Mary Ave Villas Project

Supplemental Report

CITY COUNCIL STAFF REPORT SUPPLEMENTAL

Agenda Item #8

C000.0

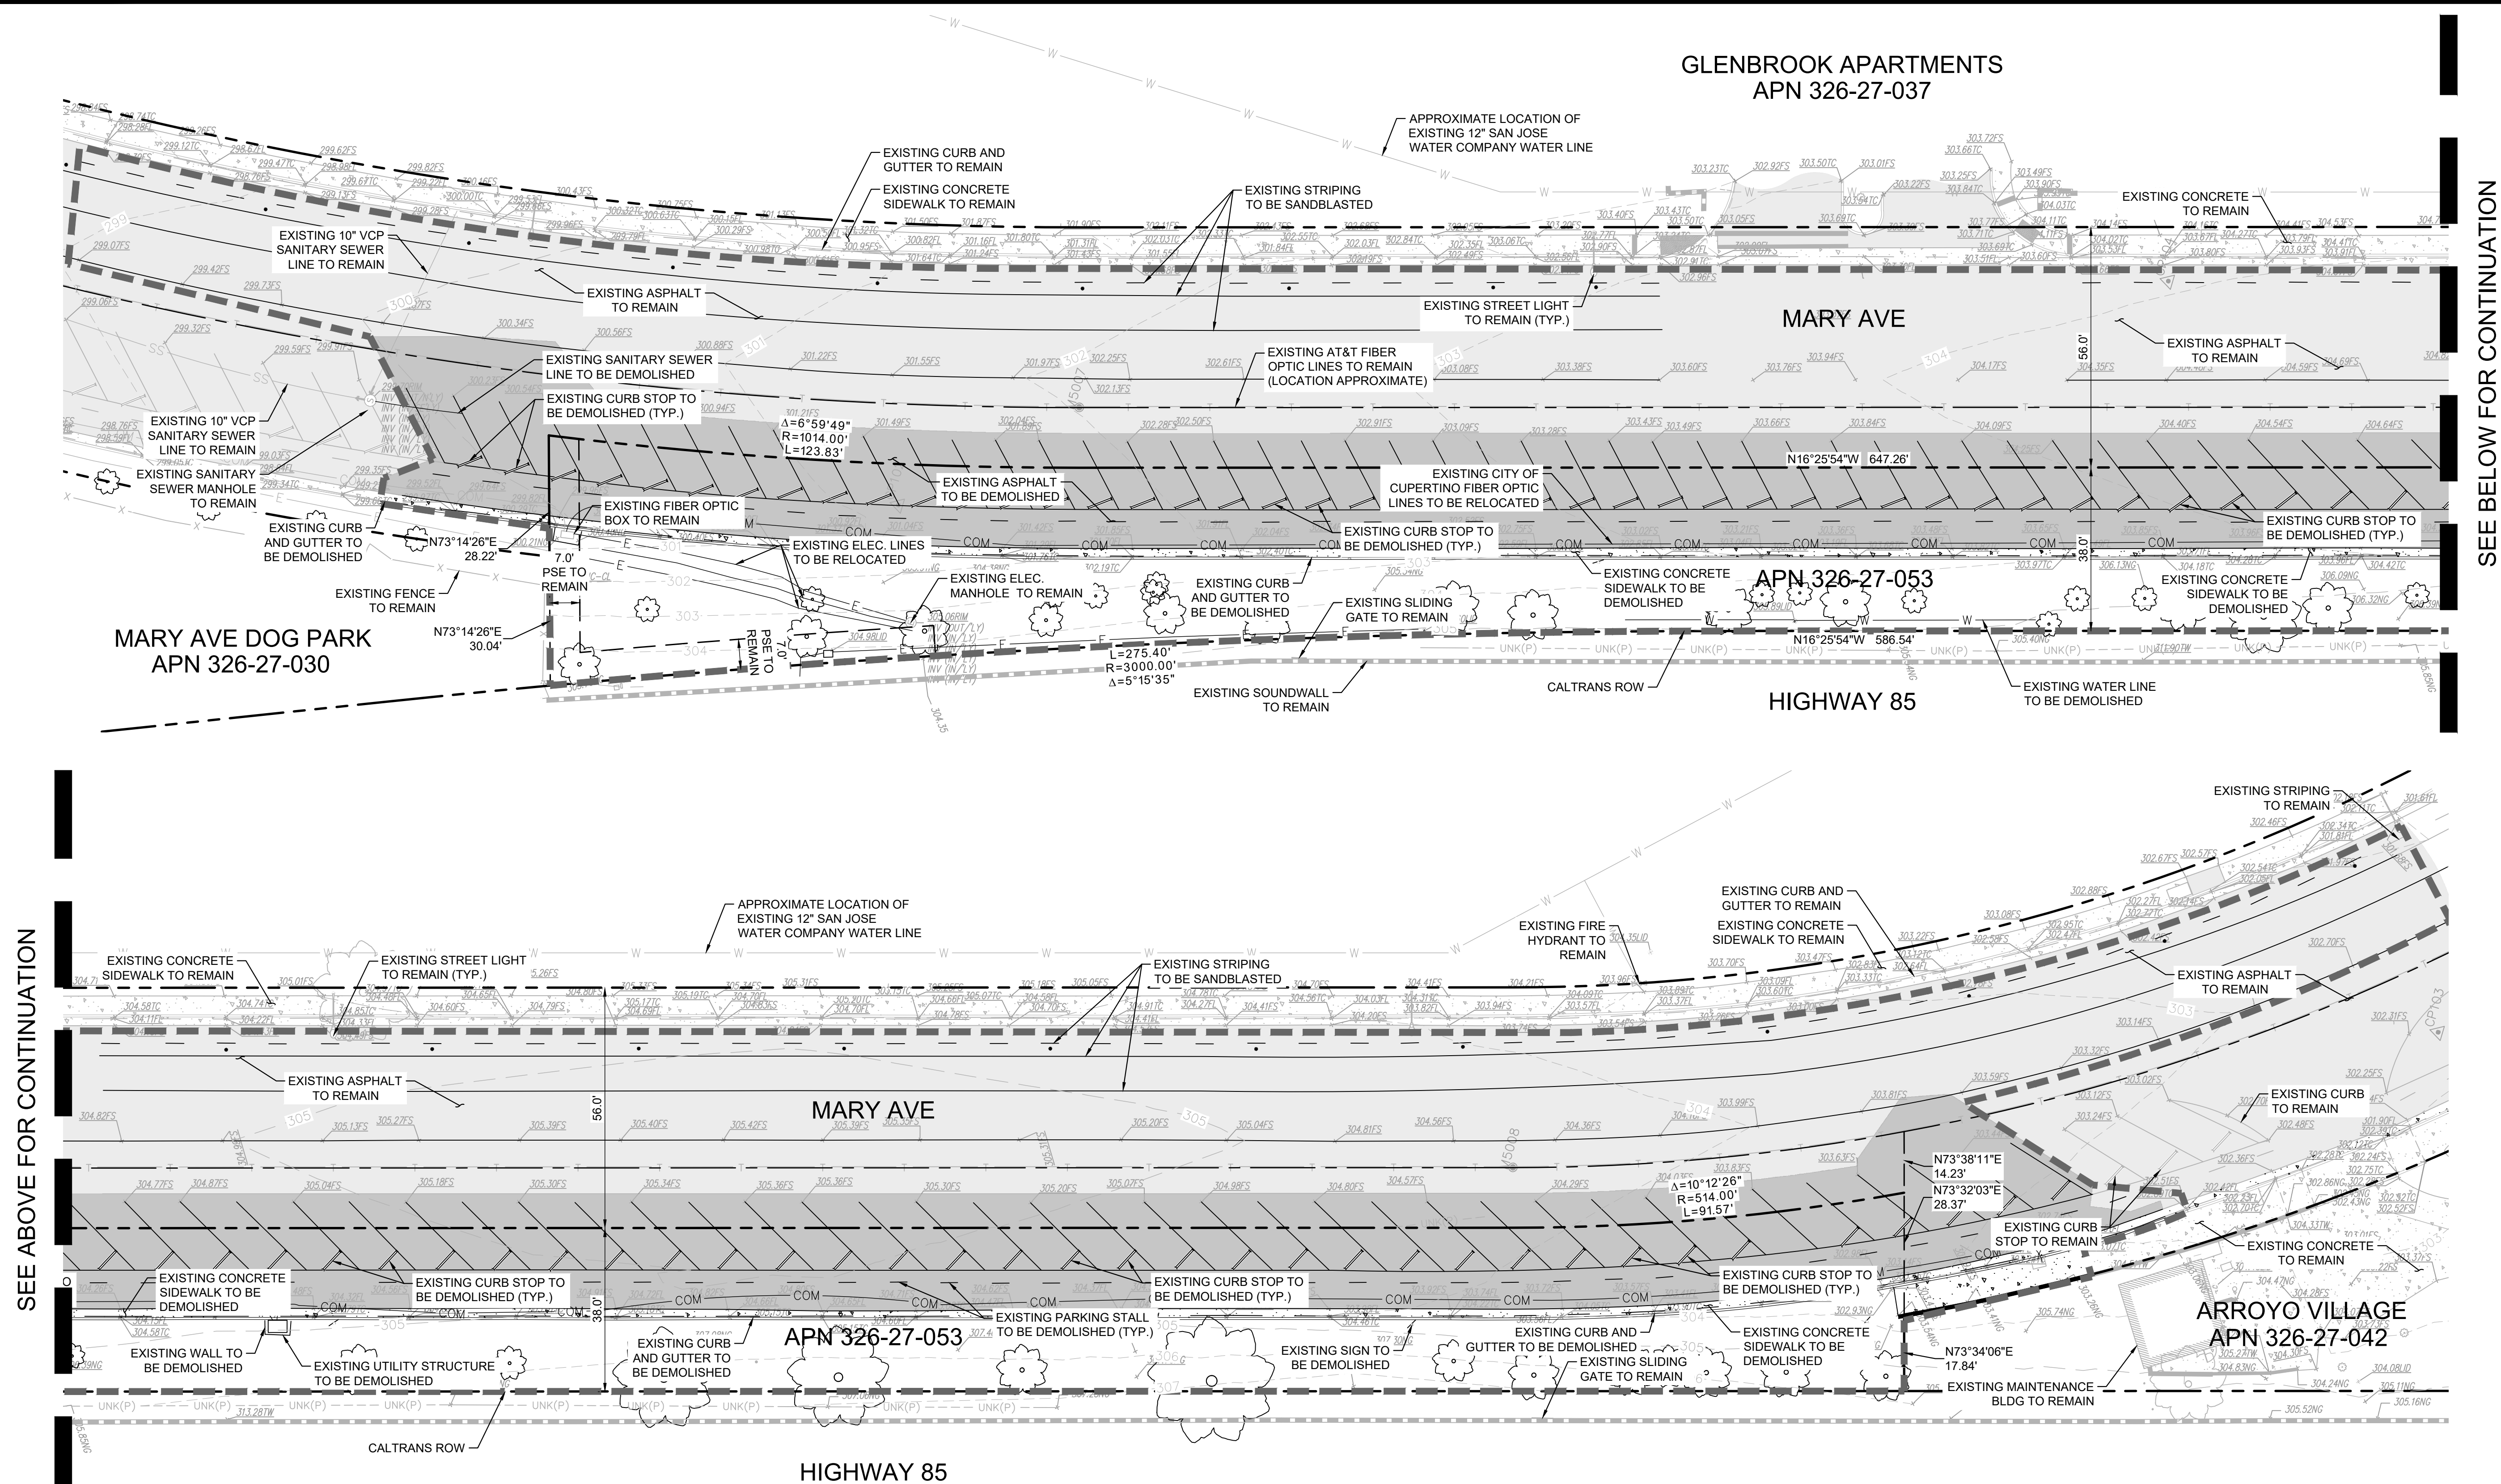
Q4: What exactly would be reconfiguration of the Mary Avenue? Please provide clear images for before and after.

Q5: What exactly are the existing parking spots and what exactly are the new ones? Please provide clear images for before and after.

Q6: What exactly would be vacated from the Public Right of Ways? There was no map included in this agenda and no map of the Public Right of Ways on to be vacated the 1/27 Planning Commission agenda. It's unclear what exactly is the dimension of the Public Right of Way to be vacated.

Staff response: The Plan Set provided with the Staff Report (Attachment F) showed the existing conditions as well as the proposed layout of the Mary Avenue Right-of-Way. Supplemental Attachment G shows sheets C000.0 (Existing Conditions and Demolition Plan), C001.0 (Preliminary Site Plan), and C005.0 (Sections), which had been included in the Plan Set that had been provided with the Staff Report.

Staff response: Sheet C000.0 shows the property line of the parcel to be vacated (Supplemental Attachment G). Further, Supplemental Attachment H (Parcel Map) shows a clean dimensioned parcel without the proposed development and/or existing conditions overlaying onto the sheet.
